Re: Oak Bluff Bowling Alley - Acoustic Review

We have performed our acoustical review of the proposed design, the acoustical evaluation and recommendations by Cavanaugh Tocci Associates, Inc. on February 19<sup>th</sup> and February 26<sup>th</sup> 2014 and provide the following as our acoustical comments and considerations. We have commented on what has been provided. Other work, reports, designs and recommendations may be in process or have been completed and we would be glad to provide further review of other materials if requested.

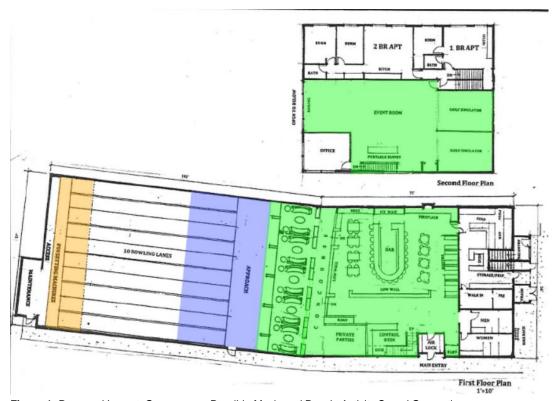
Based on measurements at other bowling alleys, both novice and experienced bowlers vary the way they bowl which can make ball impacts on the lane smooth or of very high impact. The noise levels associated with Bowling Balls impacting the lane/floor when bowling can be in the range of 105 dBA (including low frequency content of 98 dB at 31.5Hz octave band and 110 dB at both 63Hz and 125 Hz octave bands) measured at the edge of the lane (around 5 feet from the Ball impact). The area shown in PURPLE in figure 1 below is the likely area where balls will impact the floor. Bowling activities measured in the pinsetter area at a distance of around 5 feet above the pin-setting machine with balls being bowled, pins being impacted and the ball hitting the pit-cushion at the end of the lane can be in the range of 110 dBA (including low frequency content of 90 dB at 31.5Hz octave band and 95 dB and 105 dB at 63Hz and 125 Hz octave bands

respectively. The area shown in ORANGE in figure 1 below is the pinsetter machine areas where balls will impact pins and the end of the lane.

Our assessment of the proposed design, with recommended upgrades to the walls (to provide an STC 62 rating) and ceiling (to provide around an STC 60 rating) indicates that sound levels at the residential property boundary during these impulsive events associated with bowling activity will likely be in the range of 55 dBA, and thuds or thumps associated with ball impacts will be audible on the exterior. If the ambient sound environment in the residential area adjacent to the proposed Bowling Alley is a quiet location, we would expect that this sound level would be clearly audible. Because of the impulsive nature of these thumps, we do not consider this sound could be considered to blend into the existing ambient sound conditions as these events are distinct and likely different from the existing sound conditions.

We note that the proposed design has excluded the programming of live music, however we noted no assessment of amplified music sounds and how these sounds may transmit to the adjacent residences or how these sounds may be controlled from the Bar or the second level Events space. Amplified Music (from a DJ, etc.) can be as loud as live music or live bands (and may be as loud or louder than bowling). These areas are highlighted in GREEN in figure 1 above.

In order to control sound levels from these areas to suitable limits, 10 dB below measured ambient levels in each octave band, specialty constructions may be needed including double isolated independent stud construction for the exterior walls with multiple layers of drywall or sheathing on each stud row, independent drywall ceilings below the roof with multiple layers of drywall and insulation, separate pours of concrete to isolate impacts of bowling and pinsetter areas and music areas from the structure supporting the exterior stud row of the building envelope and fiberglass batt insulation in all exterior constructions. In addition to the primary issues above of Bowling Alley and Music Sounds being transmitted, the proximity of the proposed building and its various systems to the residential boundary may make any noise emitting systems important for consideration and possibly for noise mitigation. In other locations, where the proximity of a residential boundary is not as close as in this case these systems may not require consideration from a noise mitigation standpoint. In this case, we suggest that some narrative and explanation of the expected noise impact relative to ambient sound conditions be provided for operational equipment and systems including but not limited to; Air Conditioning systems, Kitchen Exhaust Systems, Music Amplification Systems, Bowling Systems, and Refrigeration Systems.
